Well Name: JOHN DENVER 15/14 FED COM	Well Location: T18S / R29E / SEC 15 / SWSW /	County or Parish/State: /
Well Number: 526H	Type of Well: OIL WELL	Allottee or Tribe Name:
Lease Number: NMNM0437524	Unit or CA Name:	Unit or CA Number:
US Well Number: 3001554412	Well Status: Drilling Well	Operator: MEWBOURNE OIL COMPANY

Notice of Intent

Type of Submission: Notice of Intent	Type of Action: APD Change
Date Sundry Submitted: 11/27/2023	Time Sundry Submitted: 11:03
Date proposed operation will begin: 12/01/2023

Procedure Description: Mewbourne Oil Company request that the following change be made to the John Denver 15/14 B2LI Fed Com #1H (APD ID # 10400084742): 1. Change well name f/ John Denver 15/14 B2LI Fed Com #1H (APD ID # 10400084742) to John Denver 15/14 Fed Com #526H. 2. Attached Plat with new well name. 3. Request a variance to perform break testing and offline cementing per attachments. 4. Attached Break Testing and Offline Cementing variance.

Figure 1. Cactus 13 3/8" 5M offline cementing tool. Pressure rating limited by the lesser of 5M tool rating or the 13 3/8" pup joint and casing.

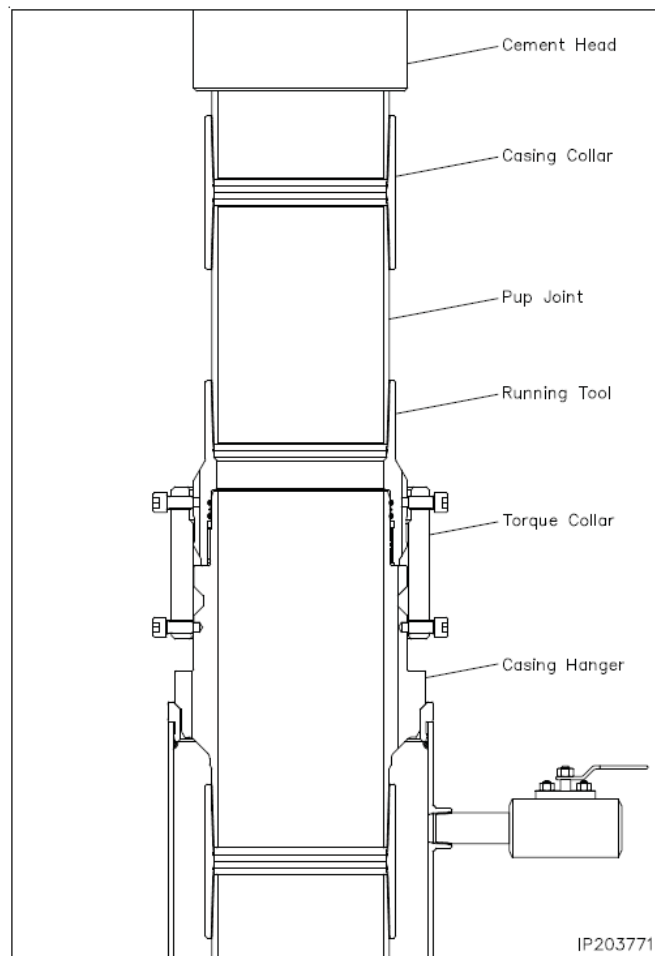
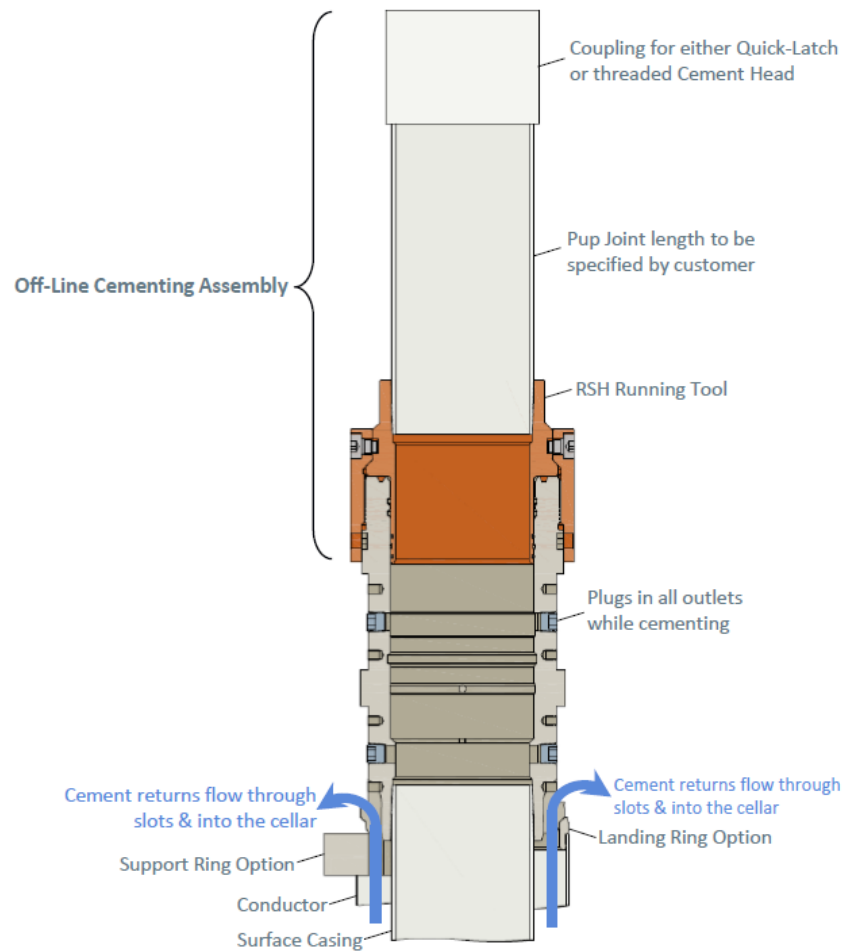
9. Make up offline cement tool with forklift per wellhead manufacturer (Fig. 1 & 2).
10. Make up cement head on top of offline cement tool with forklift.

Figure 3. Cactus 9 5/8" 5M offline cementing tool. Pressure rating limited by the lesser of 5M tool rating or the 9 5/8" pup joint and casing.

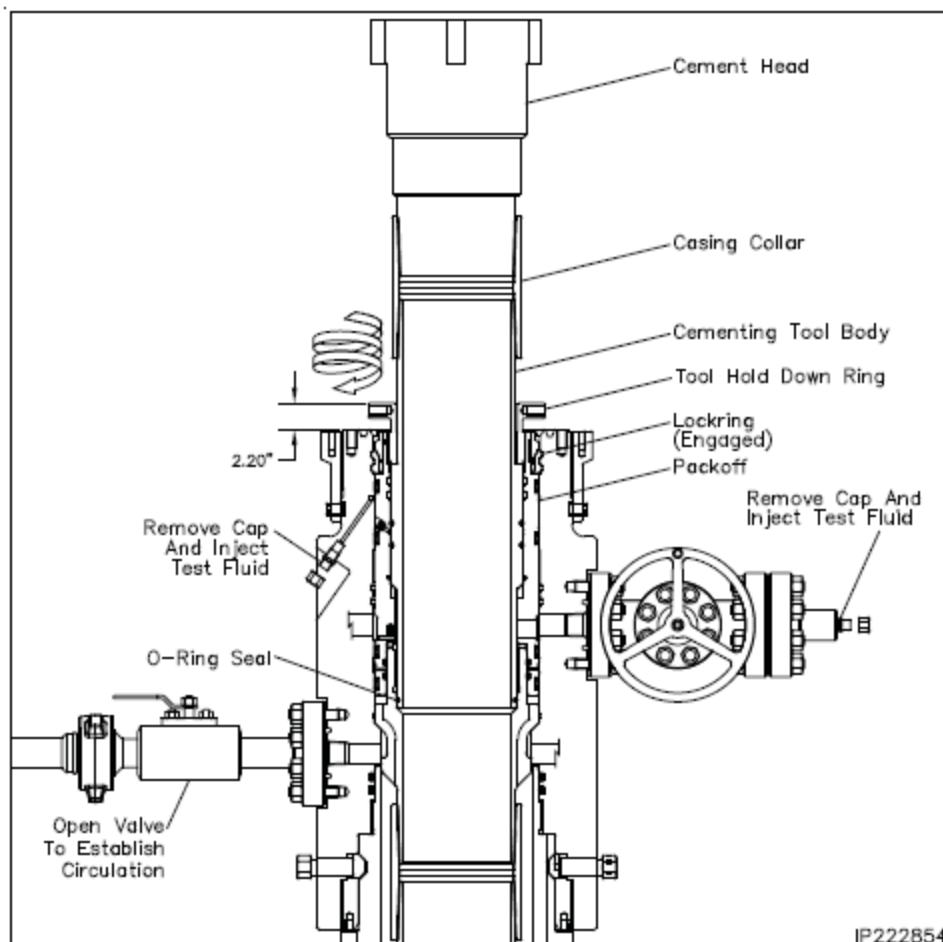
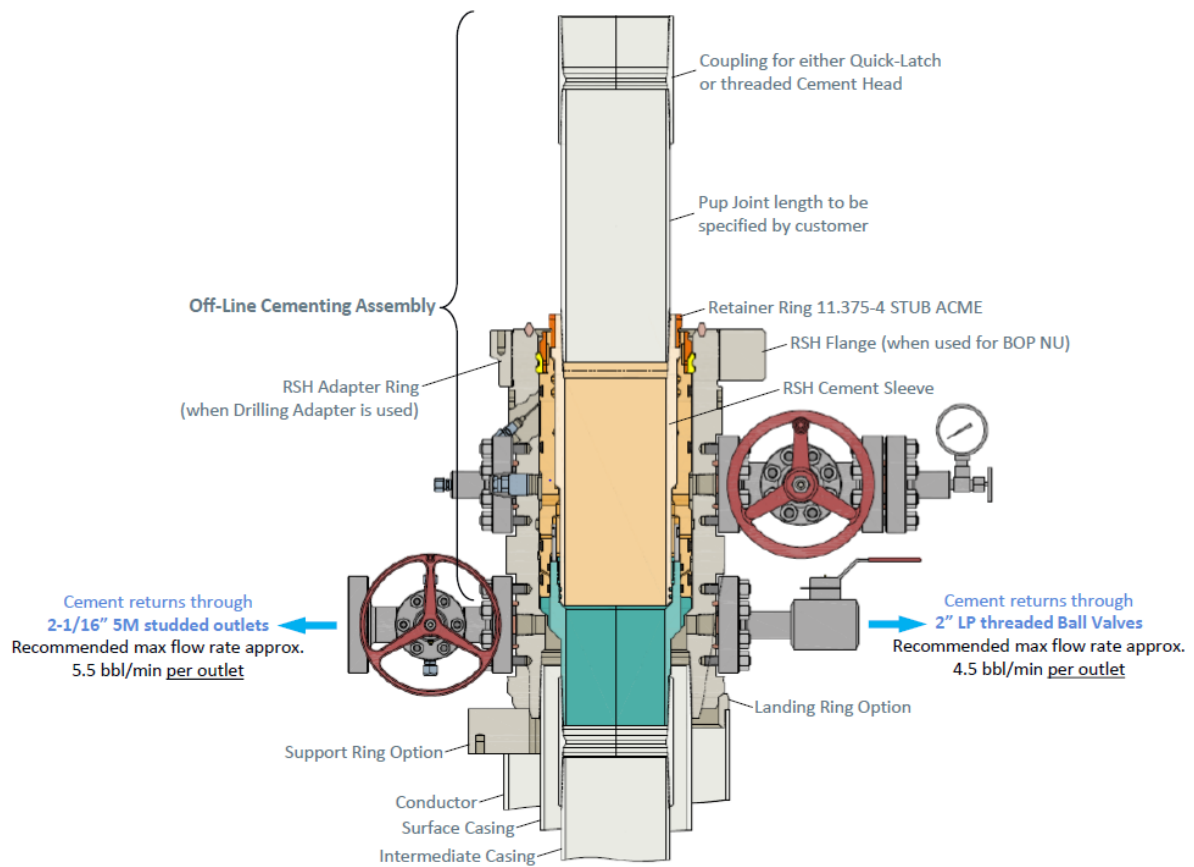
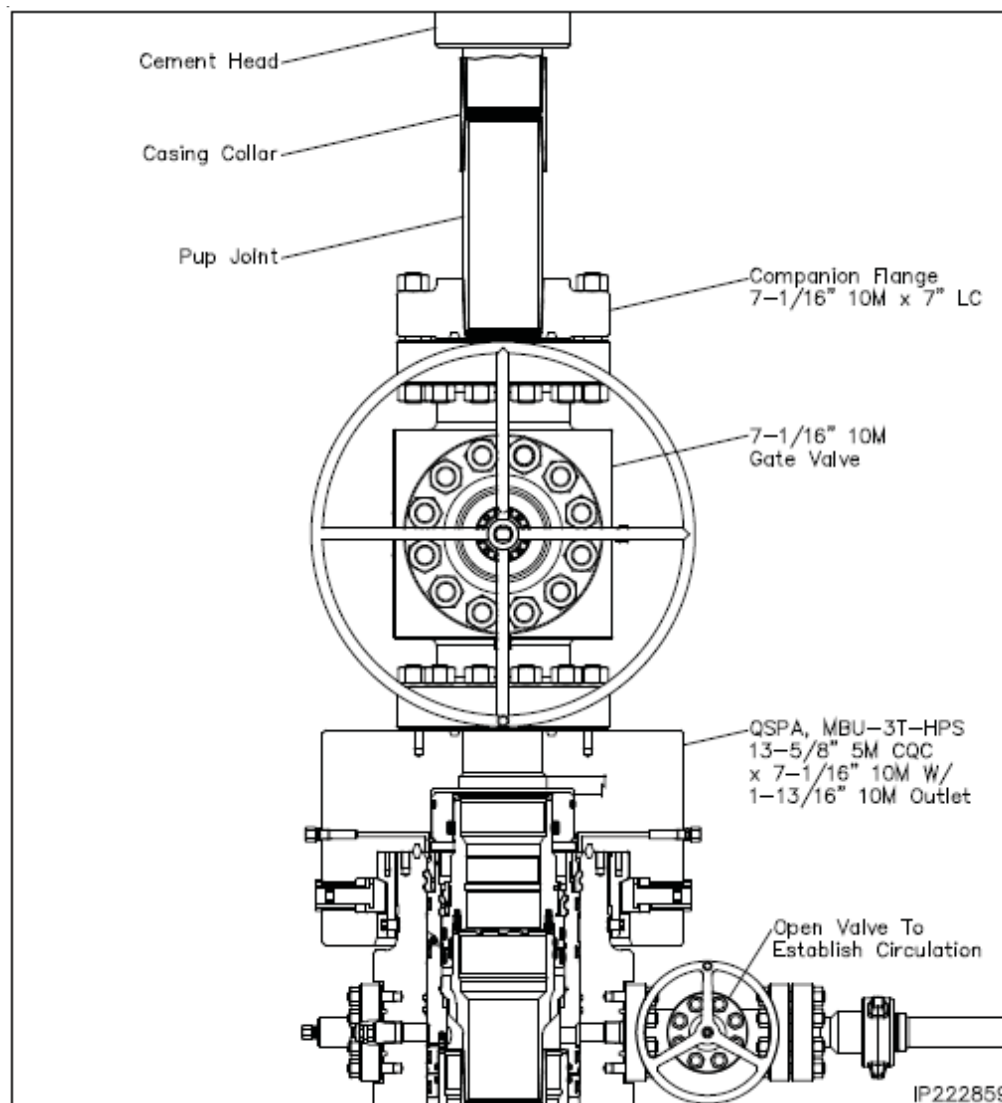
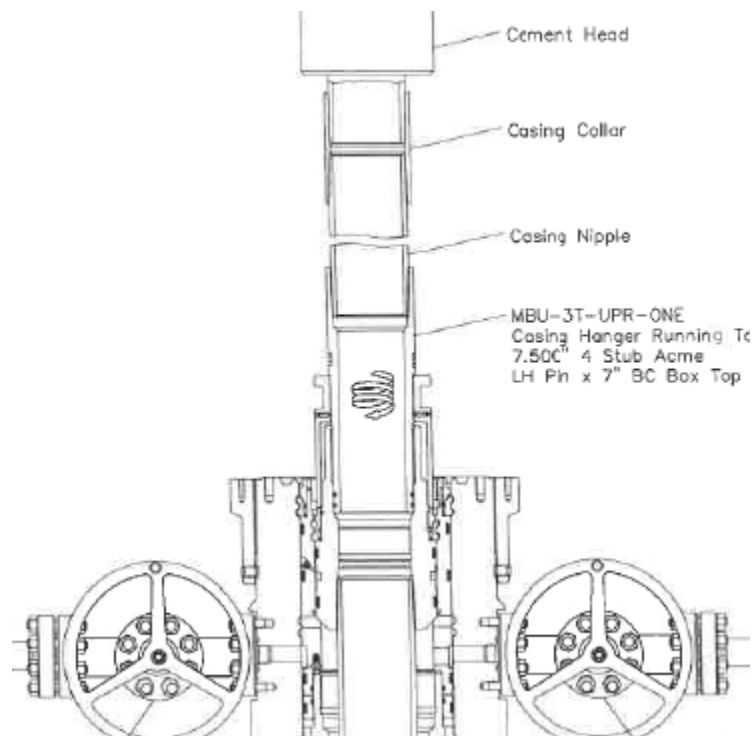
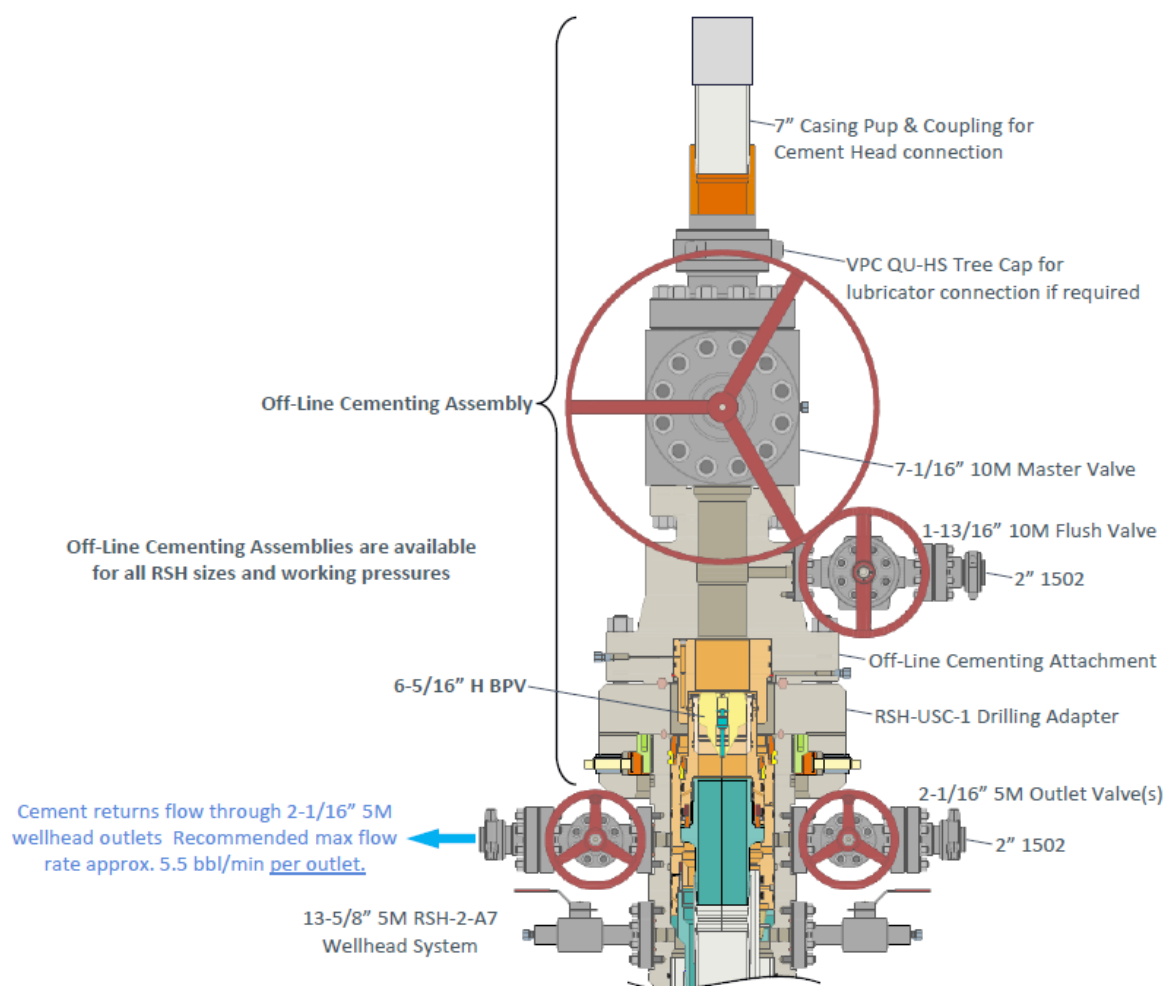
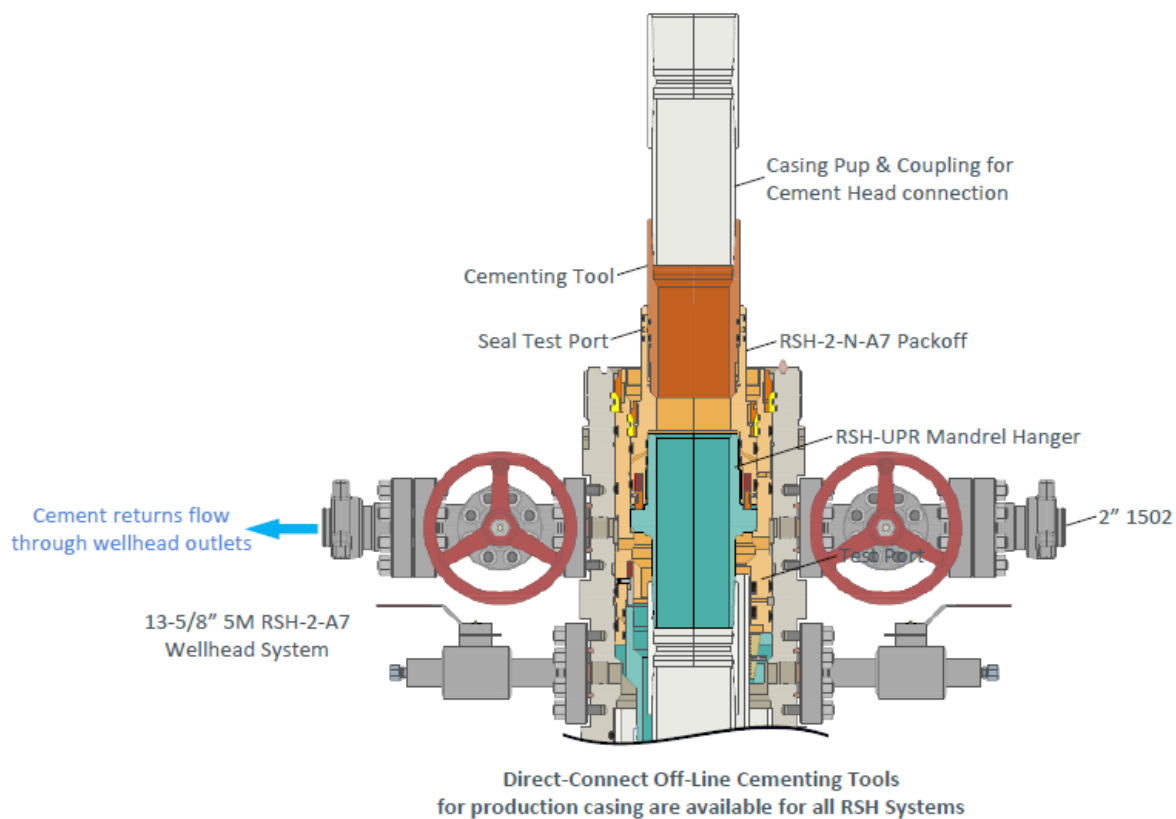
10. Make up offline cement tool using forklift per wellhead manufacturer (Fig. 3 - 8).
11. Make up cement head on top of offline cement tool.
12. Commence cement operations.

Figure 9. Five valve 15k choke manifold.

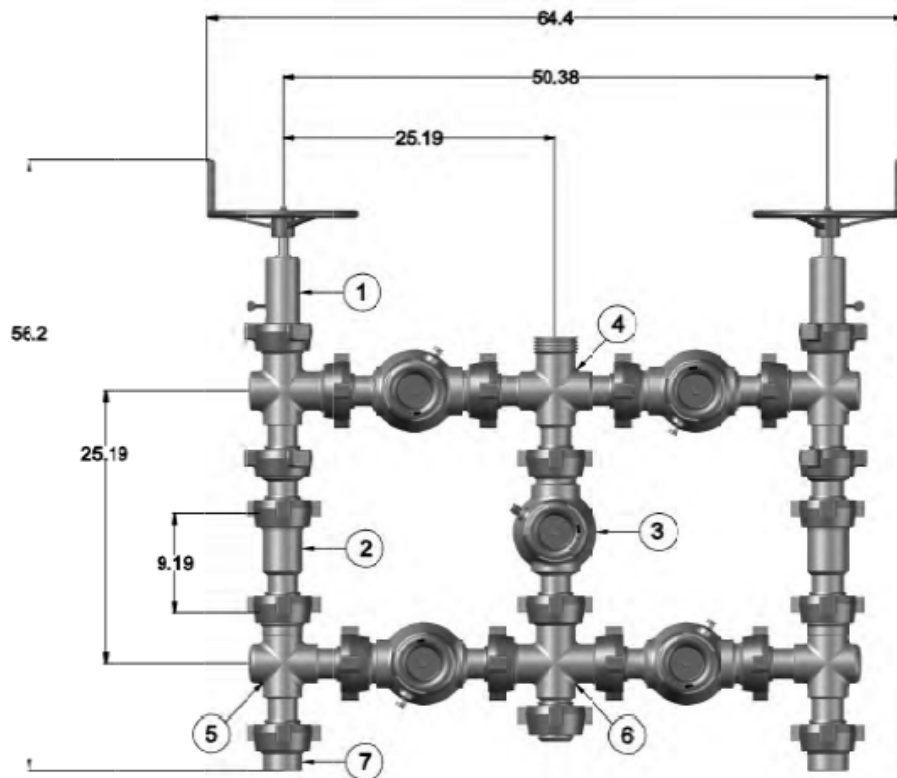
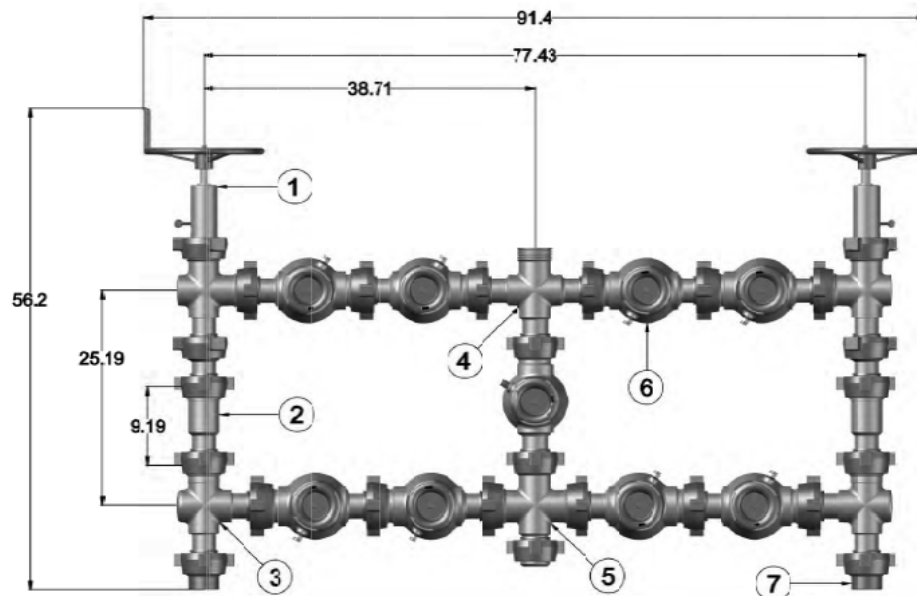
- Pressure build up in annulus before cementing
 - o Contact BLM if a well control event occurs.
 - o Rig up 3rd party pump or rig pumps to pump down casing and kill well.
 - o Returns will be taken through the wellhead valves to a choke manifold (Fig 9 & 10).
 - o Well could also be killed through the wellhead valves down the annulus.
